Eastridge to BART Regional Connector

Second Addendum to the Final Second Supplemental Environmental Impact Report

January 2020

EASTRIDGE PARKING LOT EXHIBIT

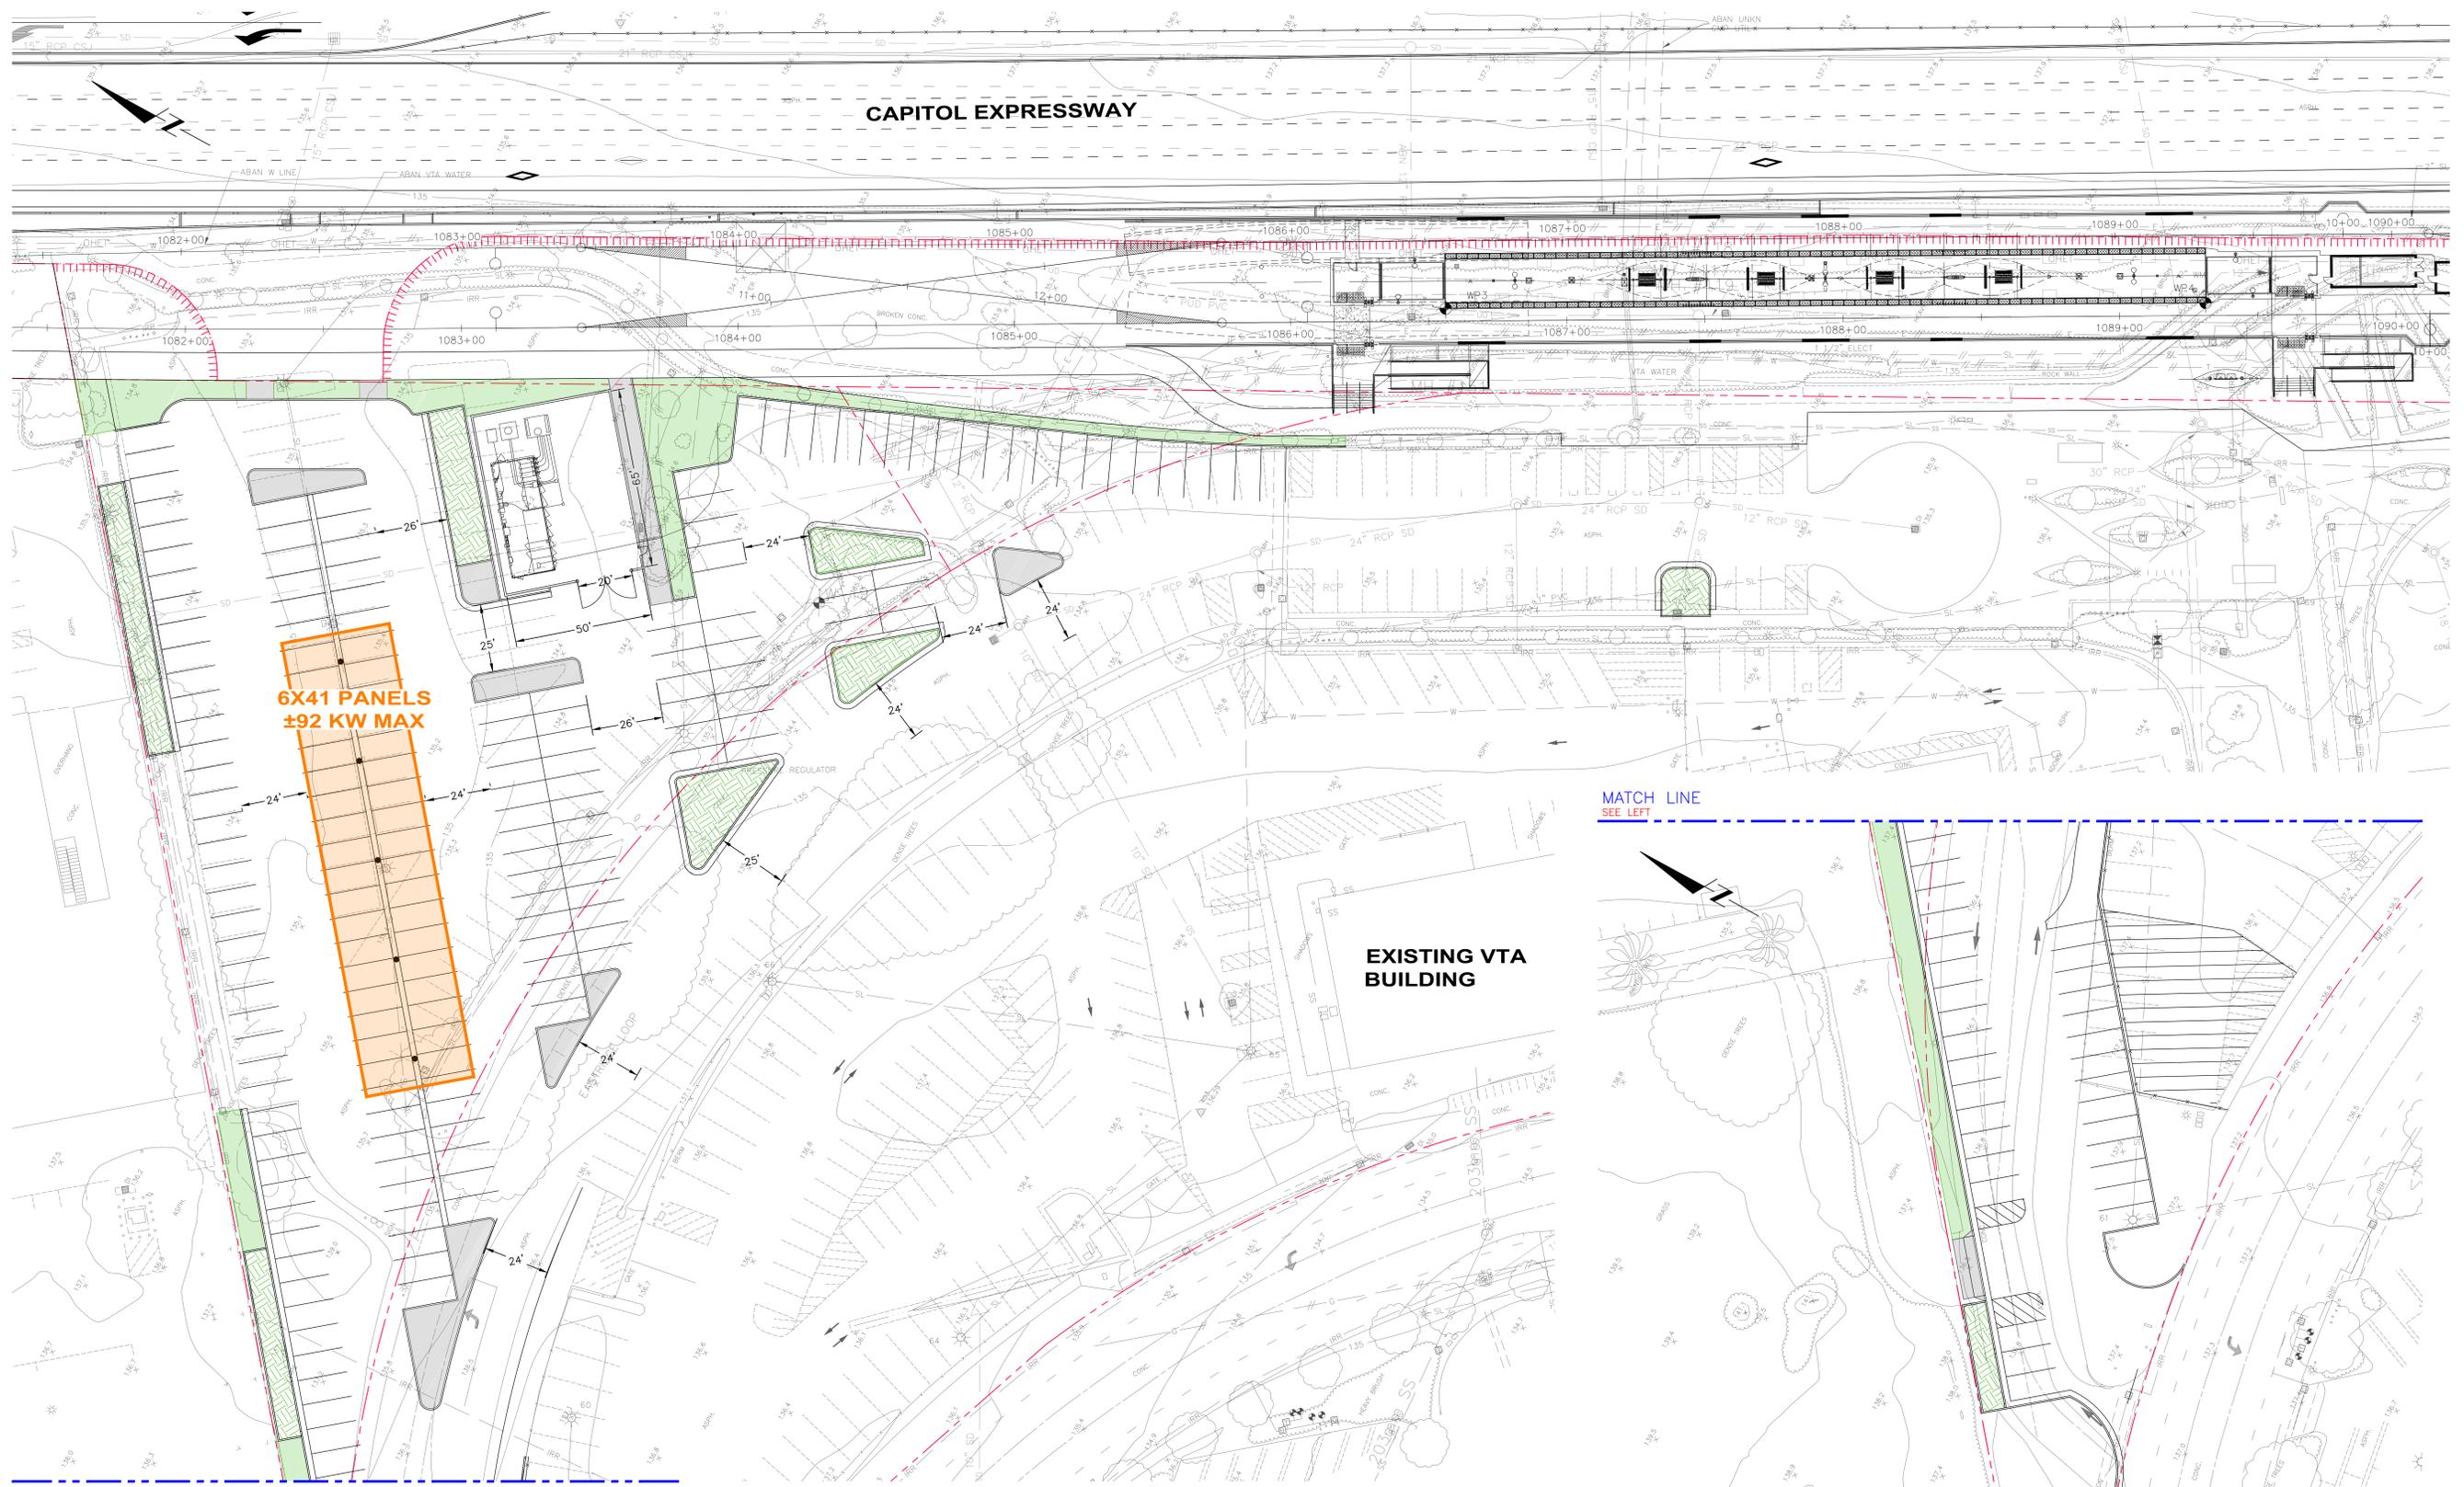
- **Design Change #5 – Include parking canopies with photovoltaic system at Eastridge Park-and-Ride Lot**

The Project will include a 92 kW photovoltaic system on parking canopies located in the Eastridge Park-and-Ride lot to reduce the grid electricity requirements of the light rail station and park-and-ride lot (Figure 3).
